TECHNICAL INFORMATION

Engine Harness Routing

No: 86/05/00/NAS
Ref:
Issue: 1
Date: 10/27/00

Discovery Series II (LT)

Figure 1

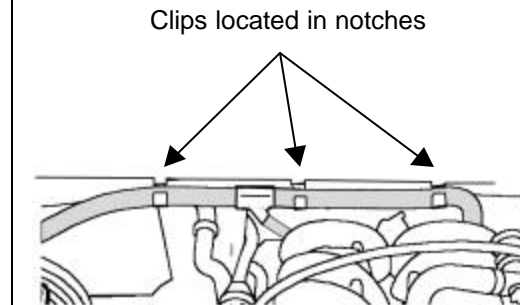
1. Remove the rubber seal from the edge of the cowl.
2. Refer to Figure 1. If clips are all located in the firewall notches, the right clip must be relocated as described below:

**CAUTION:** The right clip must *not* be located in the notch to the right of the brake pipe clip.

- Relocate the clip on the passenger (right) side of the vehicle to a location directly above the brake pipe clip. (Figure 2)
- Verify that the remaining two clips are located in the cowl notches to the drivers side (left) of the brake pipe clip.

Figure 2

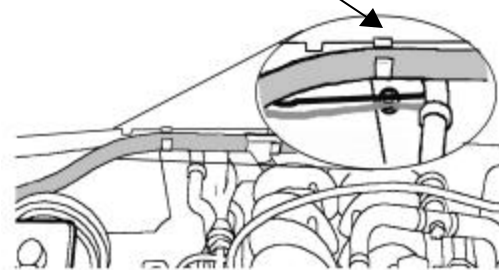
**NOTE:** There is no notch in the new right side clip location
